ISSUES OF NON-COMPLIANCE WITH THE DEPARTMENT OF TREASURY'S GUIDANCE TO MDBS FOR ENGAGING WITH DEVELOPING COUNTRIES ON COAL- FIRED POWER GENERATION

Despite this latter purpose, the Treasury Department has not adequately considered the requirements of the *Coal Guidance* in formulating its positions on the World Bank’s proposed Kosovo Power Project. The Kosovo Power Project would support the construction of a new 600MW coal-fired power plant and the rehabilitation of an existing coal plant. The World Bank recently expressed its “in principle” support for the project, and is moving it through its internal appraisal processes. The Treasury Department has consistently expressed its support for this proposal,⁴ even though it is plainly inconsistent with key provisions of the *Coal Guidance*.

New Coal Will Dramatically Raise Electricity Rates

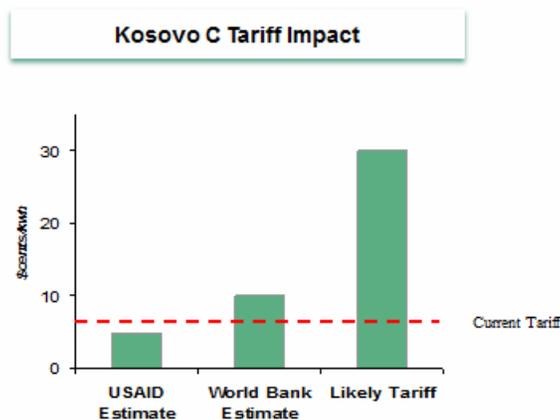
Both the Kammen and INDEP/Sierra Club studies identified alternative portfolios that could provide the needed energy services at substantially lower cost than the proposed project. The Kammen study found that its alternative low-carbon portfolio would cost 50 percent less than the proposed project (and would have greater job creation benefits and much lower environmental and social externalities).²⁵

Similarly, the INDEP/Sierra Club analysis found that the World Bank's *Background Paper* significantly underestimated the tariff increases that will be necessary to finance the simultaneous renovation of the Kosovo B plant, construction of the proposed new 600 MW plant, and the development of a new mine. This is so for two reasons. First, the Kosovo C plant will be encumbered with far higher debt costs than the currently operating units, even after Kosovo B is refurbished. The Bank's analysis does not calculate the short-term tariff increases that will be required to cover the increased fixed and operating cost of a \$1 billion dollar investment – only the Levelized Electricity Cost (LEC). And the Bank's calculation understates the true LEC by assuming that the capital costs of the project can be repaid over the entire 40 year life of the project, even though both debt and equity investors will likely expect repayment over a much shorter time frame. Second, because the new plant and the renovated Kosovo B will produce significant excess base load capacity, Kosovo B, Kosovo C, or both will have to be run at uneconomic capacity factors, substantially reducing the amount of time they will be online and generating revenue.²⁶ As a result, tariffs up to four times higher than current rates may be needed to service the total new investments.²⁷
